**KINGSTON REGIONAL SPORTS AND
ENTERTAINMENT CENTRE
REVIEW OF PARKING, SITE ACCESS, AND
EXTERIOR CONDITIONS – RELATIVE TO
ACCESS FOR
DISABLED PERSONS**

JANUARY 26, 2007

INTERMEDIATE REPORT

Figure 2 – Four Municipal Parking Lots within 200 metres of the Site

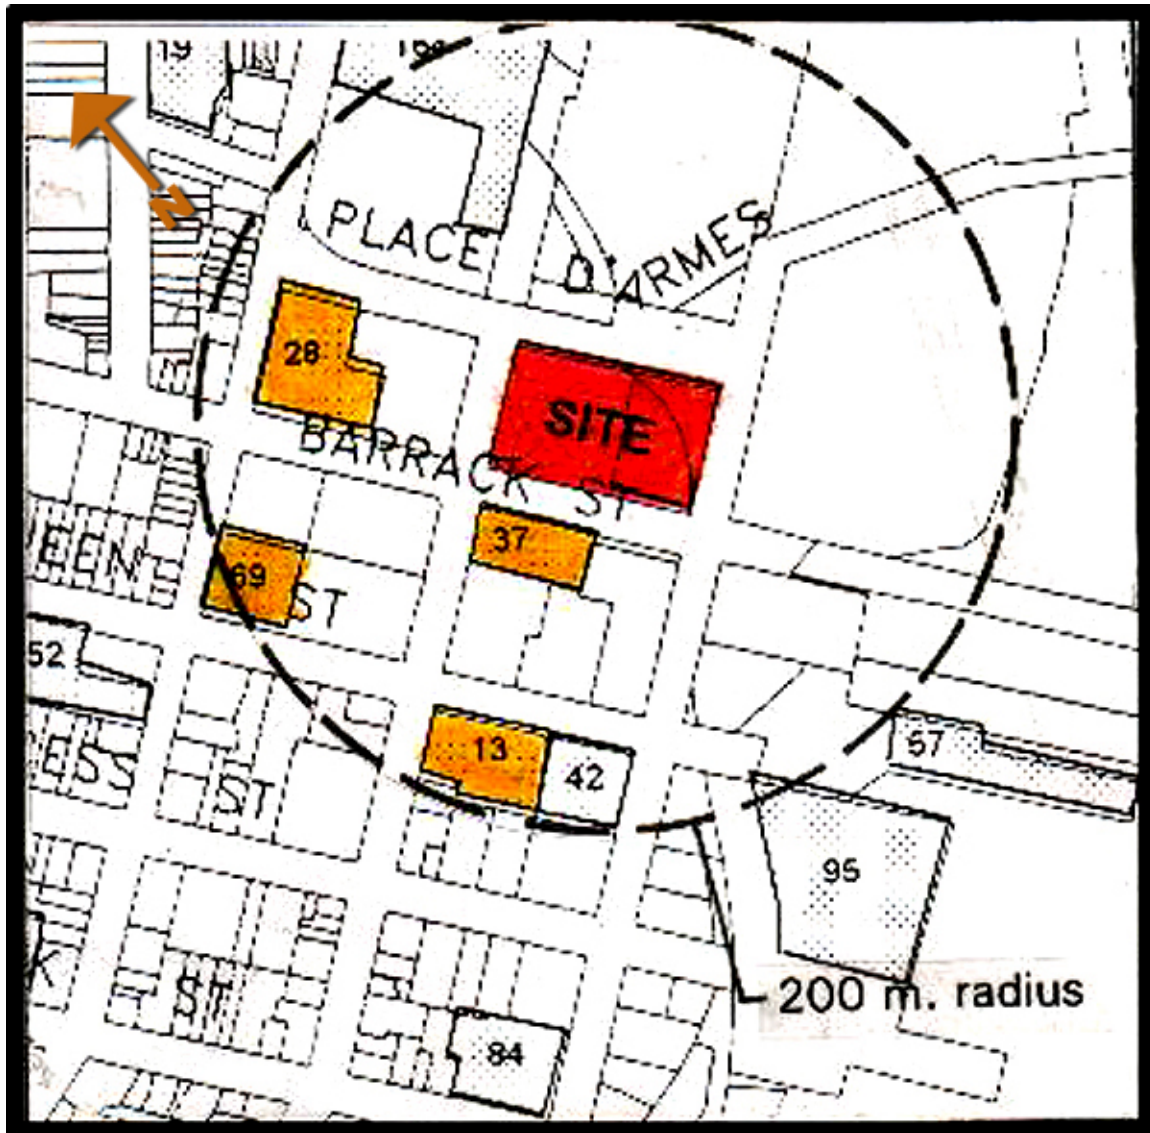
- **Provide Barrier-Free parking in four (4) municipal parking lots within approximately 200 metres of the Centre. These lots are specifically: Barrack Street, Drury, Frontenac, and King & Queen lots.**
- **Seven (7) Barrier-Free spaces already exist in the three existing lots and on-street. Assuming that safe access can be provided to all 7 of these spaces, a balance of at least twelve (12) will be provided during events only, at the Frontenac Lot. Two permanent (2) van spaces will also be provided here. These spaces should be provided adjacent the King/ Barrack Street signalized intersection to allow easy access to the ticket box office and direct entrance.**
- **Upgraded standards for the design and maintenance of Barrier-Free spaces, where provided, will be developed. Ongoing control of these spaces will be provided by bylaw enforcement.**
